P 519675
 A 518028-B

**ON-SITE SEWAGE DISPOSAL SYSTEM
 HOWARD COUNTY HEALTH DEPARTMENT
 BUREAU OF ENVIRONMENTAL HEALTH
 3525-H ELLICOTT MILLS DRIVE, ELLICOTT CITY, MD 21043
 TAX ID 03-324958**

ADDRESS: 11793 Frederick Road PROPERTY OWNER: Greenfield Homes

PLAN VIEW
SCALE: 1"=100'

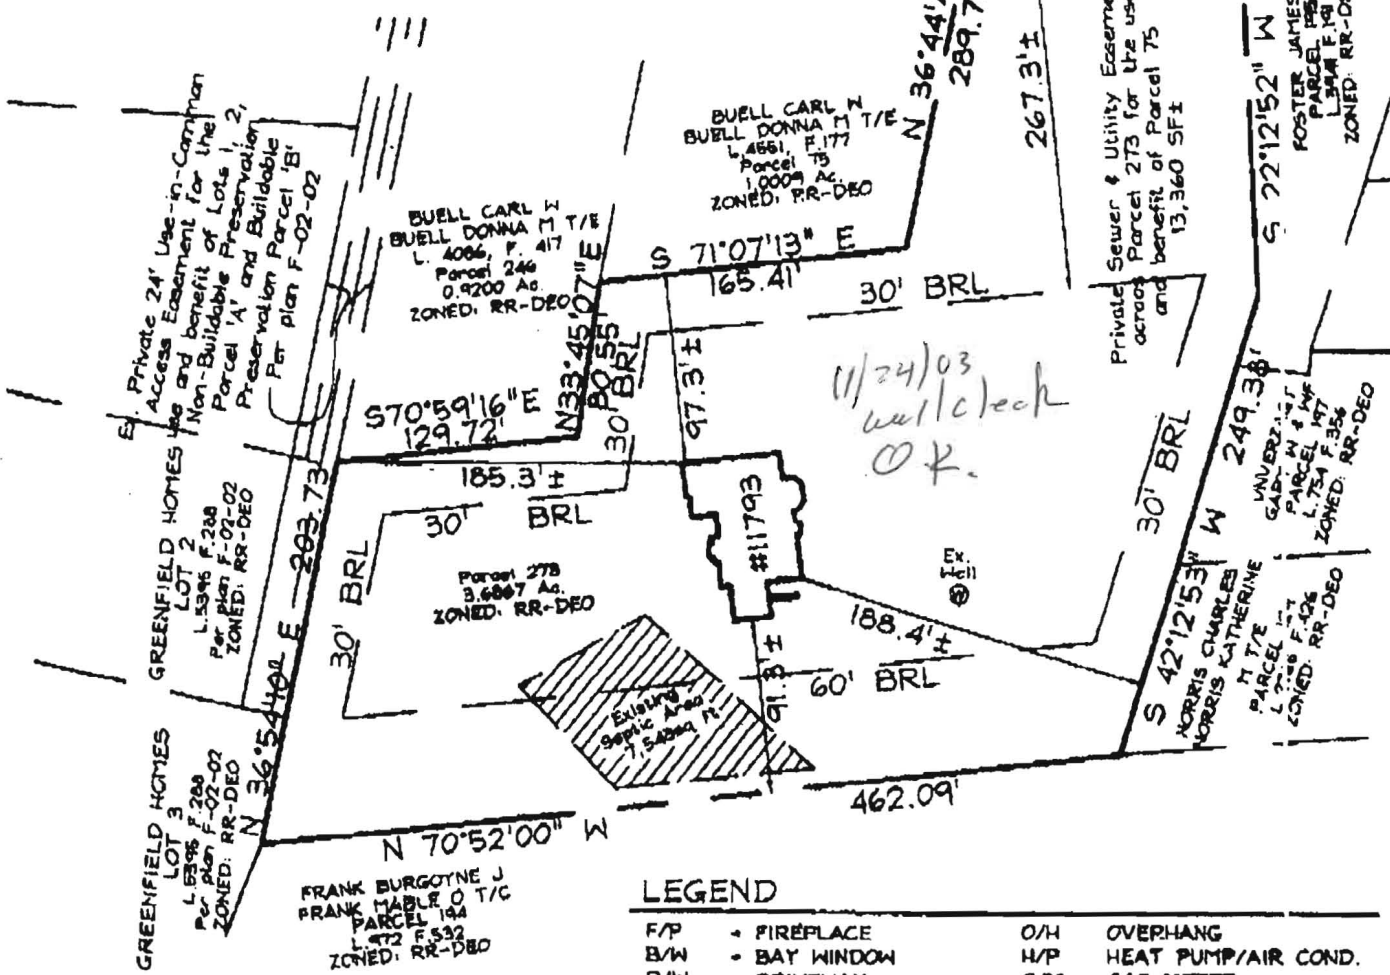
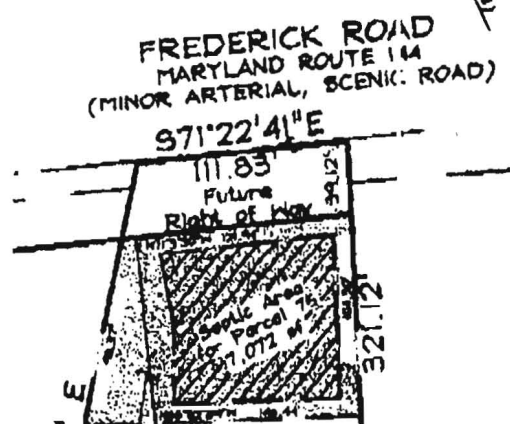
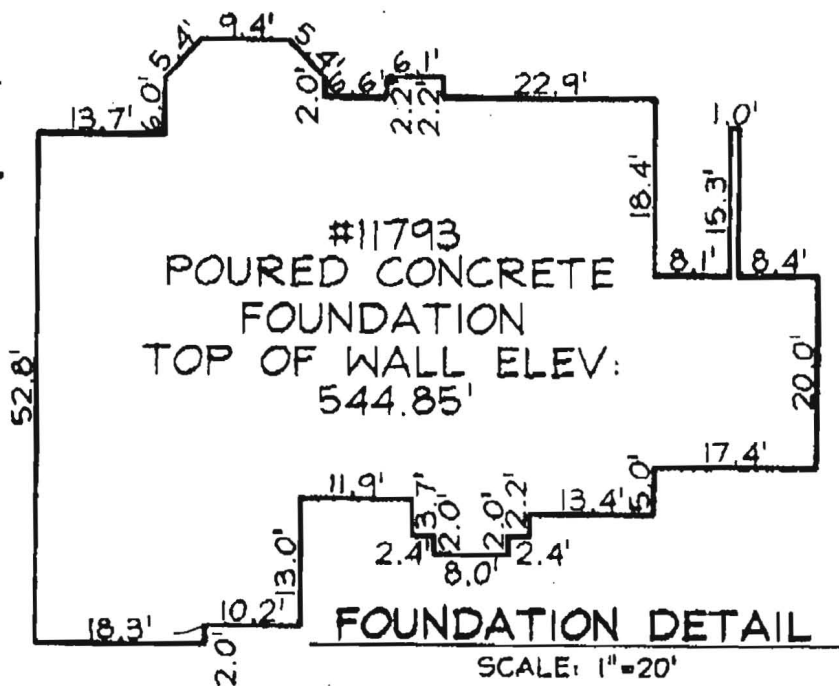
PRE-CONSTRUCTION 1/29/04 - SRA staked, contours not accurate. DK to install (2) 100' trenches 10' CTC. Top corner will be lost. (50)

INSTALLATION 1/31/04 - OK to cover all work (50)
